Subject: 2005-06 Frontier King Cab Fuel Filler Cap Recall Campaign Update #1

RECALL CAMPAIGN BULLETIN

Reference:
NTB06-036

VOLUNTARY RECALL CAMPAIGN 2005 – 2006 FRONTIER FUEL CAP TETHER

Figure 1

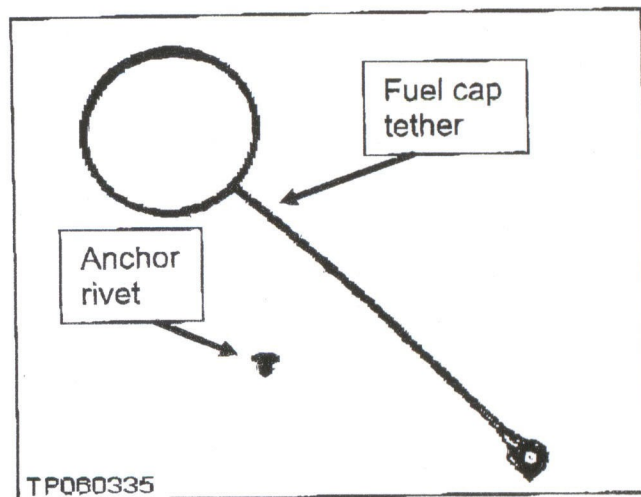
- The new fuel cap tether is slightly longer than the old one.
- Refer to the Parts Information for the part number.

Figure 5

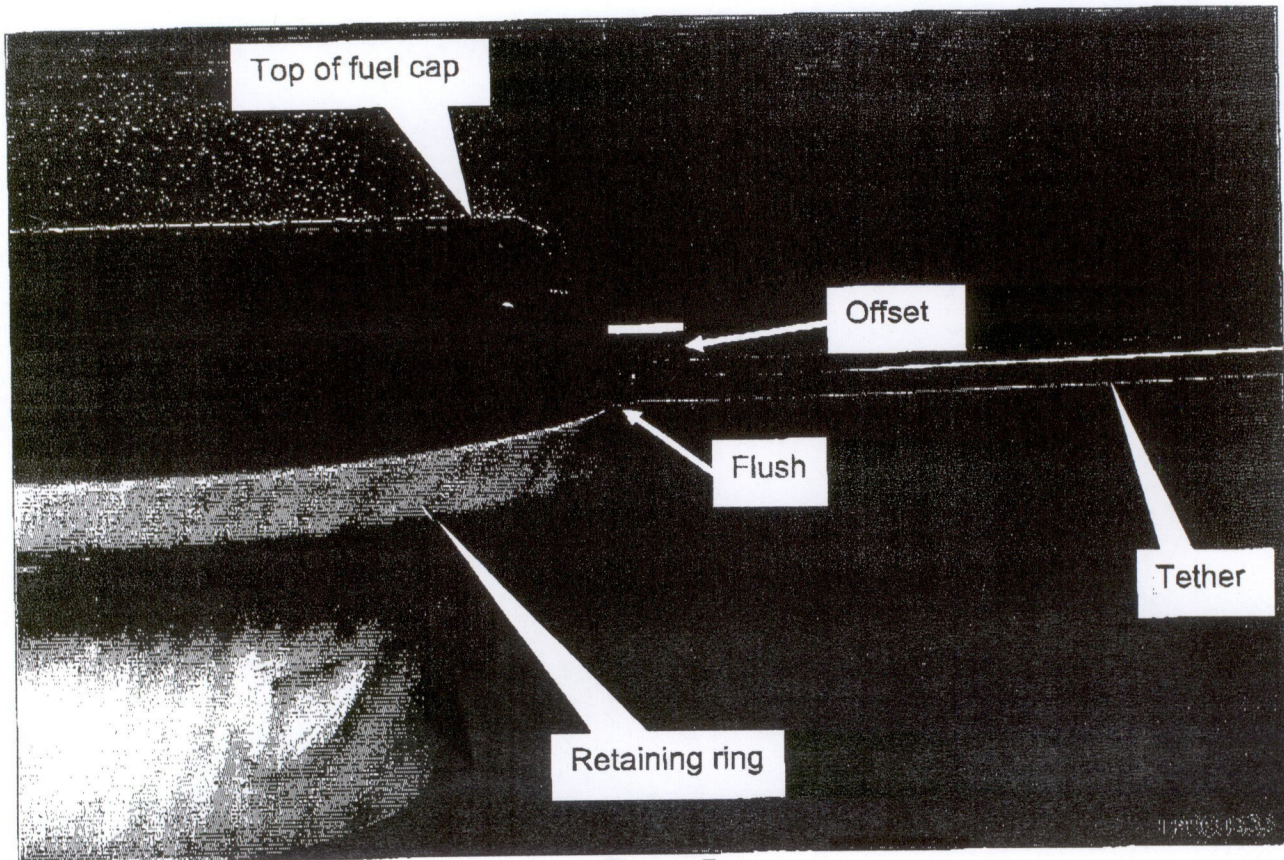
6. Install the new tether onto the fuel cap as shown in Figure 5.

- Make sure the "offset" is positioned as shown.

7. Snap the gray retaining ring back into place (see Figure 5).

- Make sure it is fully seated / snapped onto the fuel cap.
